C S Stokes and Associates Limited

17th September 2014

Subject: Grenfell Tower Grenfell Road London W11 1TQ

Hoarding at the road level.

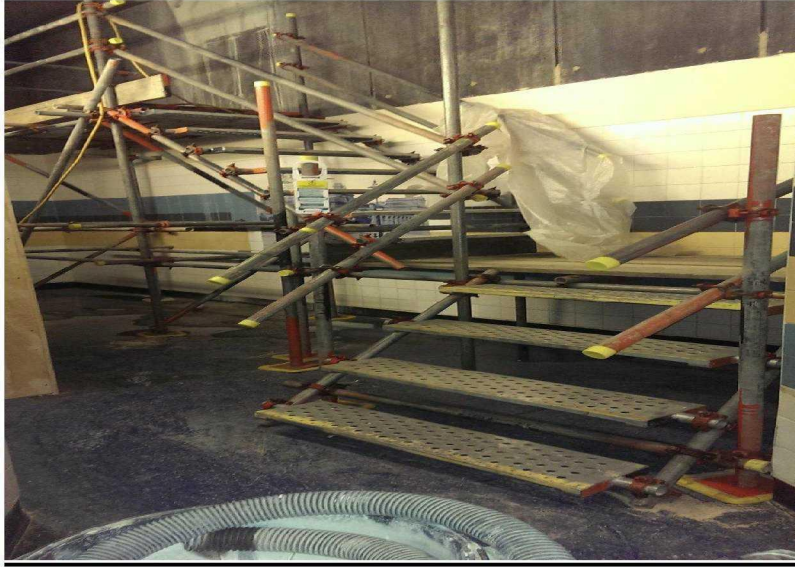
Hoarding has been erected in front of the lift doors so a person is trapped in this small gap if they exit the lift, this has been like this since the start of this month, I was told that the hoarding is to be removed this week. When it is removed there will be a scaffold staircase up to the site office, this is the only way out of this area and the only way out of the site office while the demolition of the upper part of the external staircase is undertaken. This part of the old lift lobby area will then be partition off from the remainder of the ground floor area.

5. Can it please be confirmed that the TMO are happy with this access and egress arrangement for residents of this building? , there will only be single travel at certain times and the Building Regulations only allows 18 metres for a single

travel distance. This is in effect a basement area as you have to go up to leave the building.

6. Has this access arrangement been considered under the Equality Act and for disable persons to use, including the staircase?

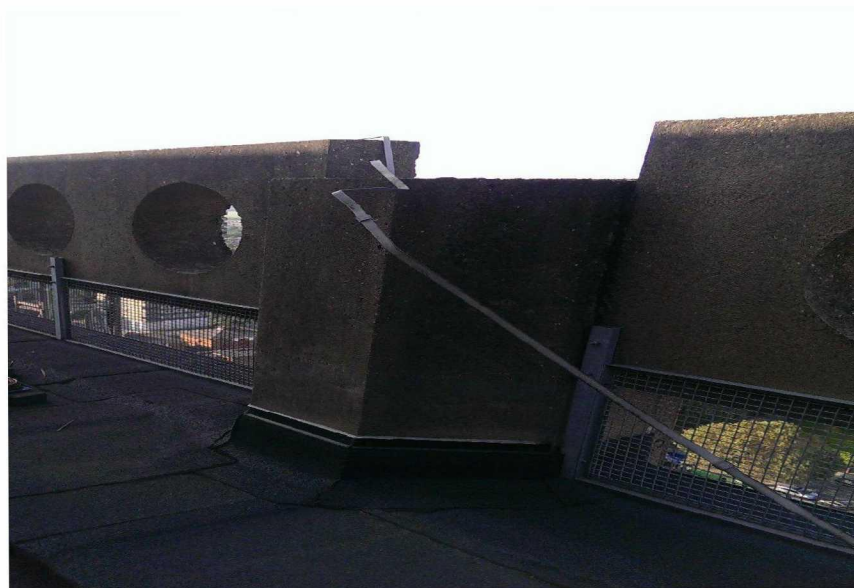
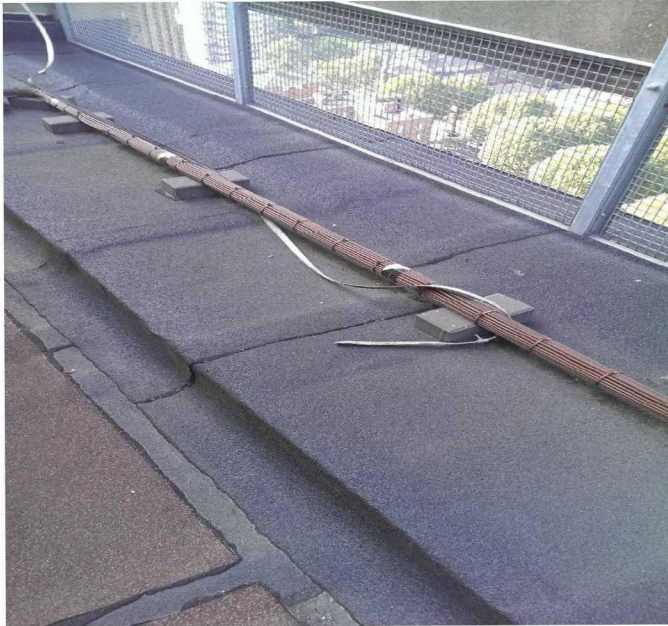
The new walkway entrance area has emergency lighting in it, but there are numerous holes in the wall linings of this area, the single door to the lift lobby area is inward opening so therefore restricts its use to a maximum of 60 persons, this door is damaged and grounds. The locking mechanism of the main entrance doors is damaged and the fire fighter over ride switch did not work when tested. The project manager stated that the new wall separating this lobby area from the remainder of this floor level is a fire rated one.

11. All the holes in the wall linings of the new entrance hall area should be fire stopped using suitable fire rated materials.
12. The single door to the lift lobby area should be repaired or replaced with a self closing fire rated door and re-hung so that it opens in the direction of travel and should close fully.
13. The new main entrance door lock should be repaired or replaced so that the door can be secured locked shut and the fire fighter over ride switch repaired or replace so that it overrides the lock on the door.
14. The pus bar signs etc should be removed from the rear exit door from the lift lobby area, this is now not a fire exit.
15. Can the contractor please provide a commissioning certificate for the newly installed emergency lighting units?

Cables on the floor and drains blocked

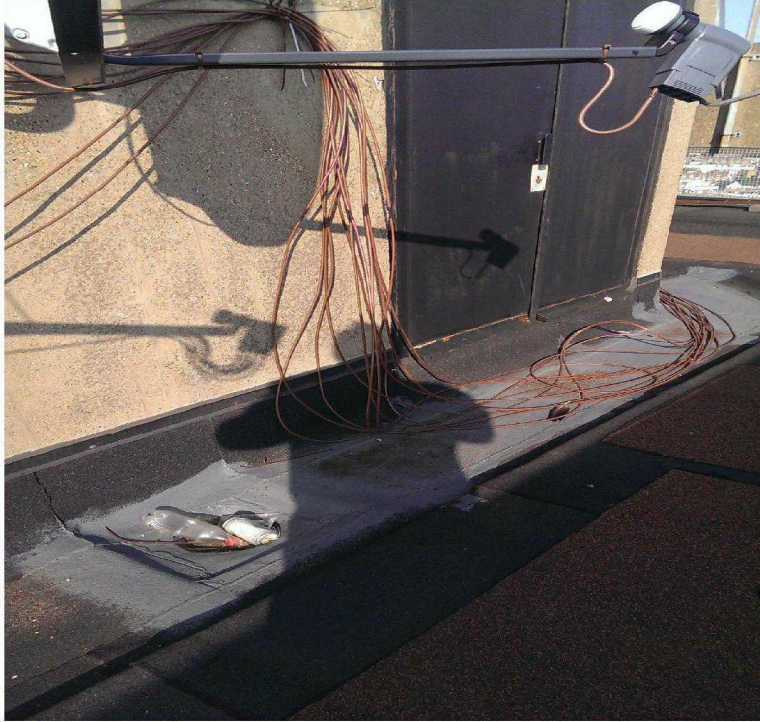
Work has been undertaken by "SCCI Alphatrack" to relocate satellite disks positioned on the face of the building to the roof level, the lightning protection system on this building has been wilfully damaged and this company have left cardboard boxes at the roof level obstructing the means of escape. The door to the external roof is damaged and does not close, there is waste and rubbish blocking the drains at the roof level and the cables are obstruction the doors to the plant areas and laid on the floor causing a

17. The installed lightning protection system on this building should be repaired immediately and a completion and or a commissioning certificate issued by the contractor to state that the system is in full working order.
18. All the rubbish should be removed from the roof level and the drains unblocked etc.
19. The door to the external roof area should be repaired or replaced and locks etc fitted so that it can be secured shut.

Cables

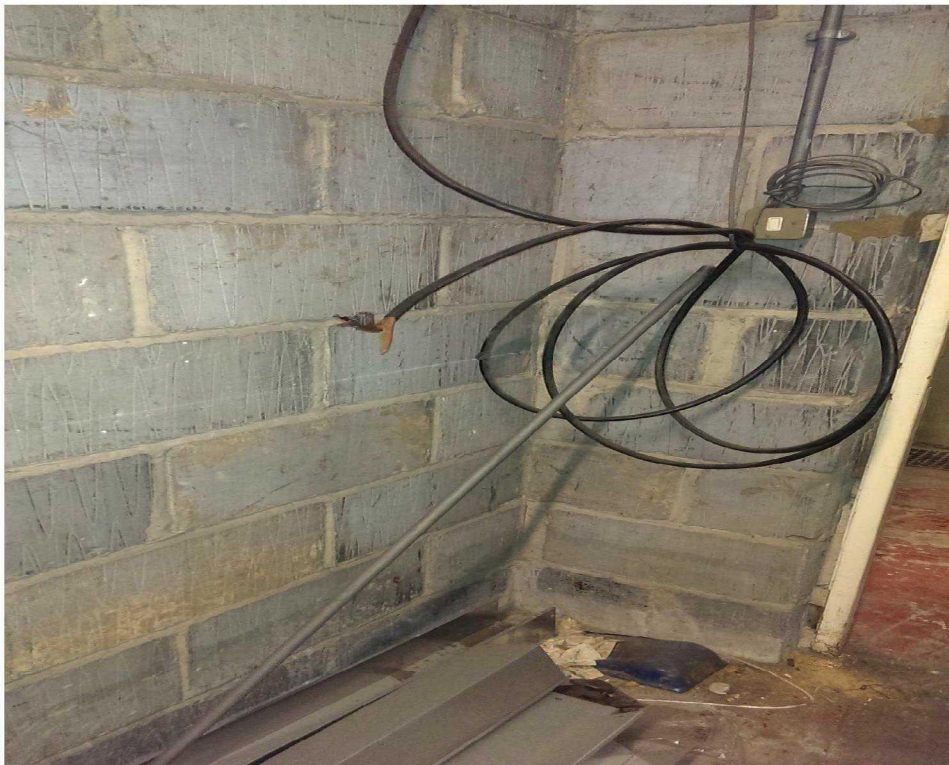
Work is being undertaken in the basement area of this building, new boilers will be installed etc, the door at the base of the staircase is damaged and there are electrical cables hanging down from the ceiling etc.

22. Can it please be confirmed by the contractor that all cut and hanging electrical cables in the basement area are not live?

23. The damaged door and door frame at the base of the staircase down to the basement should be repaired or a new door set installed.
24. The amount of combustible waste in the basement area should be kept as low as possible, with rubbish and waste removed at regular intervals, I would recommend that the contractor is asked to tidy up and remove combustible waste from this basement area.
